Access Compliance Report

Public Rights-of-Way (Curb Ramps)

Intersection ID: 10096	Main Street: SELDON_DR	Cross Street: W_TRADE_ST	Location: S
ADA ID: 293F48850351	Ramp Type: Perp	Initial Pass/Fail: Fail	Overall Compliance: No
		Severity Score: 22.5

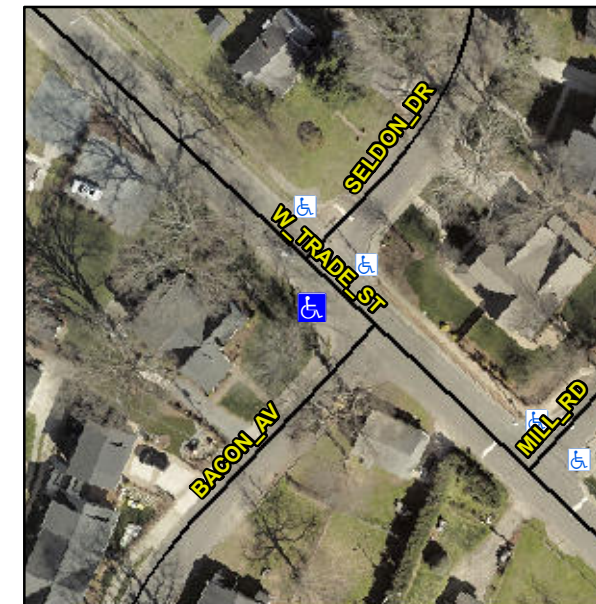
**Not Found, R304.5.1, R304.2.2,
R304.5.3**

Compliance	Description	Data	Compliance	Description	Data
N/A	Ramp Length (in)	74.0	No	Ramp Slope (%)	8.9
No	Ramp Width (in)	47.0	No	Ramp XSlope (%)	3.0
N/A	Flare Type LT	N/A	N/A	Flare Type RT	N/A
N/A	Flare Slope LT (%)	N/A	N/A	Flare Slope RT (%)	N/A
N/A	Flare Traversable LT?	N/A	N/A	Flare Traversable RT?	N/A
N/A	Landing Length (in)	N/A	N/A	DWS Provided?	N/A
N/A	Landing Width (in)	N/A	N/A	DWS Contrast?	N/A
N/A	Landing Slope (%)	N/A	N/A	DWS Length (in)	N/A
N/A	Landing X Slope (%)	N/A	N/A	DWS Full Width?	N/A
N/A	Landing Curb? (Y/N)	N/A	N/A	DWS Offset (in)	N/A
N/A	Shared Landing?	N/A			
N/A	Gutter Ponding?	N/A	N/A	Gutter Slope (%)	N/A
N/A	Gutter Lip Ht (in)	N/A	N/A	Gutter X Slope (%)	N/A
N/A	Painted X Walk1?	No	N/A	Painted X Walk2?	N/A
	X Walk 1 Direction	To NE		X Walk 2 Direction	N/A
N/A	X Walk 1 Width (in)	N/A	N/A	X Walk 2 Width (in)	N/A
	X Walk 1 Slope (%)	2.2		X Walk 2 Slope (%)	N/A
	X Walk 1 X Slope (%)	2.9		X Walk 2 X Slope (%)	N/A

Remove & Replace Entire Ramp.
